**ALBERTA TRANSPORTATION SPRINGBANK OFF-STREAM RESERVOIR PROJECT  
RESPONSE TO NRCB AND AEP SUPPLEMENTAL INFORMATION REQUEST 1, JULY 28, 2018**

Errata  
May 2019

## 10 ERRATA

Figure IR589-1 Seasonal Variation Metrics of Total Suspended Sediment in the Elbow River Mainstem and in the Glenmore Reservoir from 1979 to 2016

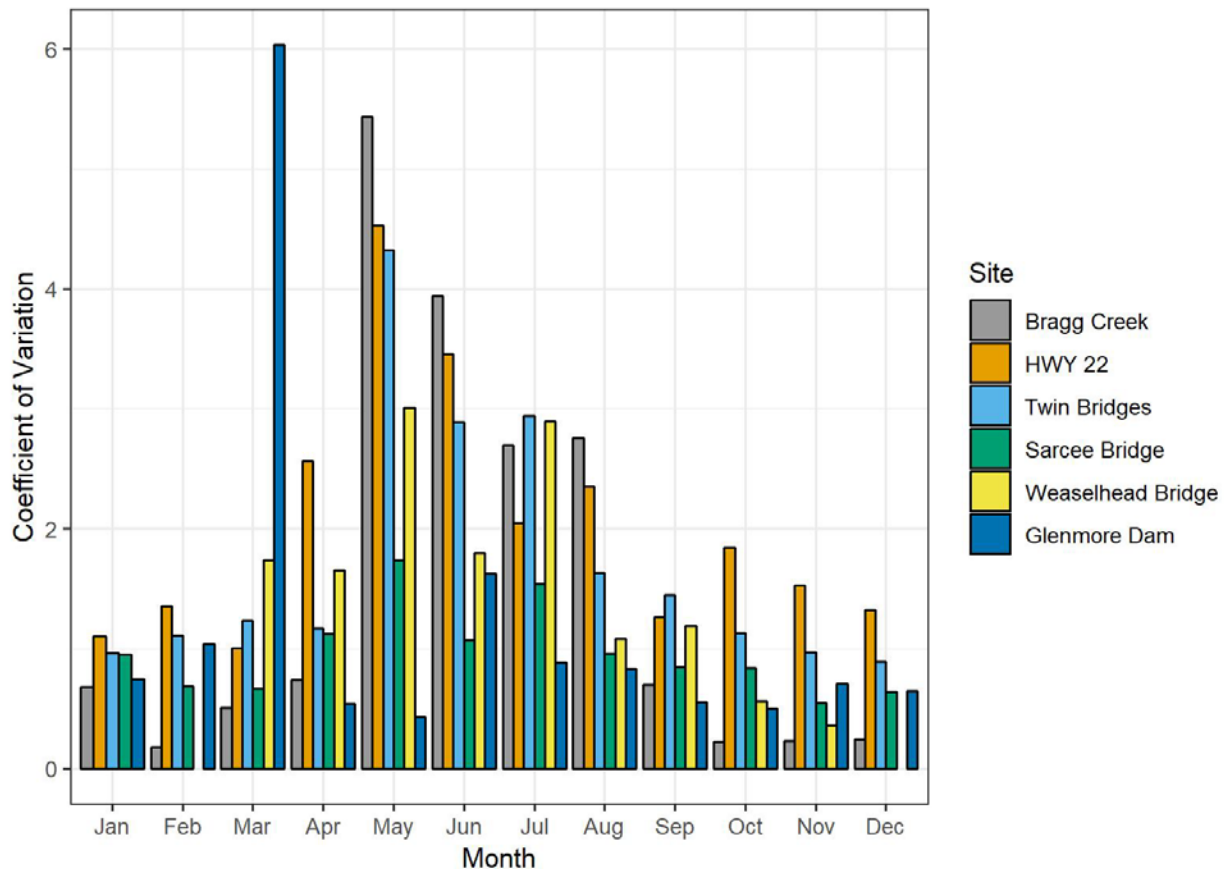
The graph is supposed to show the seasonal variation for the Elbow River mainstem and at the Glenmore Reservoir. The Glenmore Reservoir bars are missing.

- a. Add the Glenmore Reservoir bars and provide the updated graph.

- a. Figure IR589-1 provides the requested additional information.

Figure IR593-1 Monthly Total Suspended Sediment Seasonal Variability Metric (using data from 1979 to 2016)

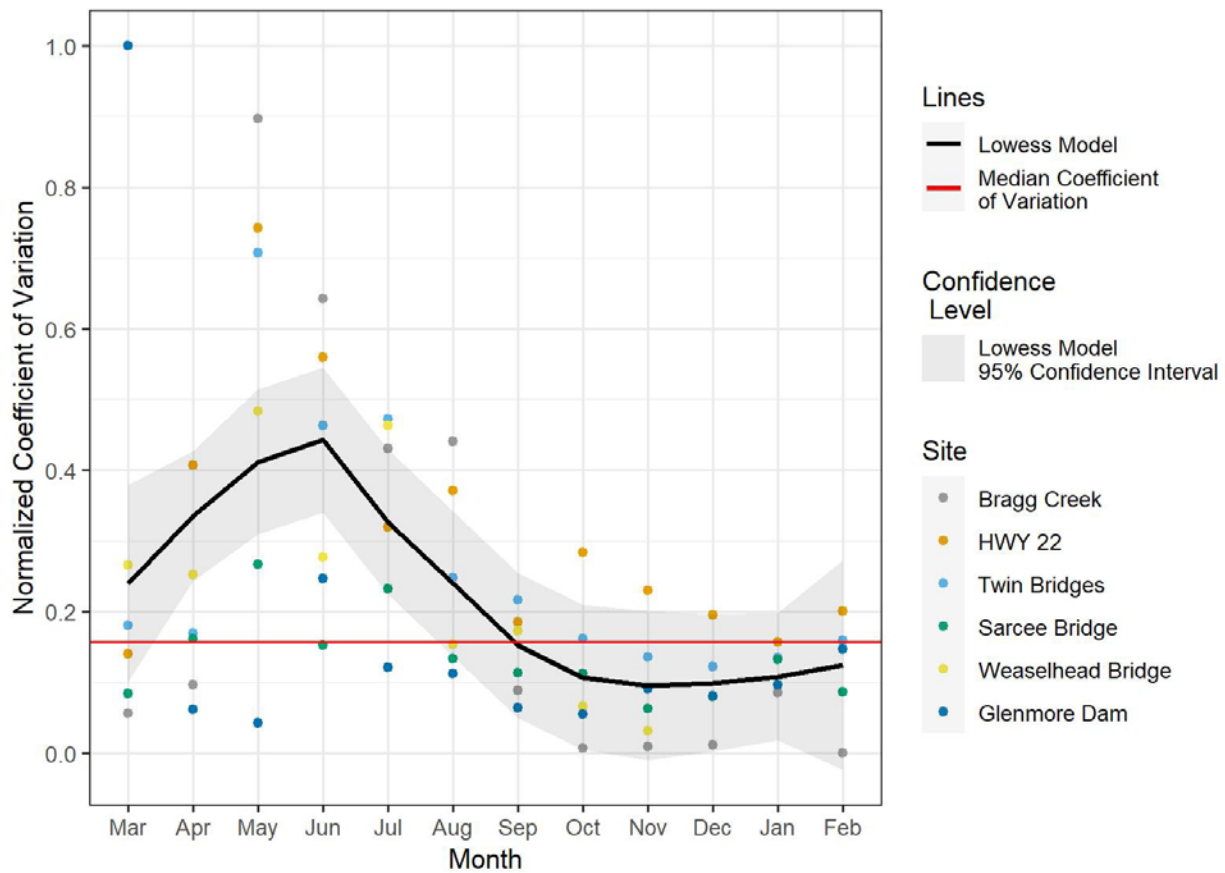
The figure has a legend for different lines and areas in the graph.

- b. Explain why all five dots for the month of May are outside the Lowess 95% confidence interval area.
- c. The figure heading indicates that it applies for the summer season; however, the 'x' axis includes months for a full year. Clarify this discrepancy.

- a. Figure IR593-1 provides the requested information.

- b. The Lowess Model curve and the 95% confidence boundaries reflect the central tendency and spread of the monthly coefficient of variations over time. The line representing the Lowess model curve (termed the locally weighted scatterplot smoothing model) and the accompanying 95% confidence intervals are smoothed to better show relationships in the data. Thus, the outside boundary of the 95% confidence interval for any one month reflects the confidence interval of the previous and post months as well. As a result, not all points fall within the 95% confidence interval.

- c. The reference to "summer" in the title for Figure 3-2 (Volume 4, Appendix K, Section 3) is regarding the area within the 95% confidence interval during summer (i.e., the area shaded yellow). This was done to provide an example on how the seasonal variation metrics for each parameter were compared to the seasonal variation metric for total suspended sediments according to season. (note: the yellow area is removed in Figure IR593-1 provided in response a to avoid confusion).
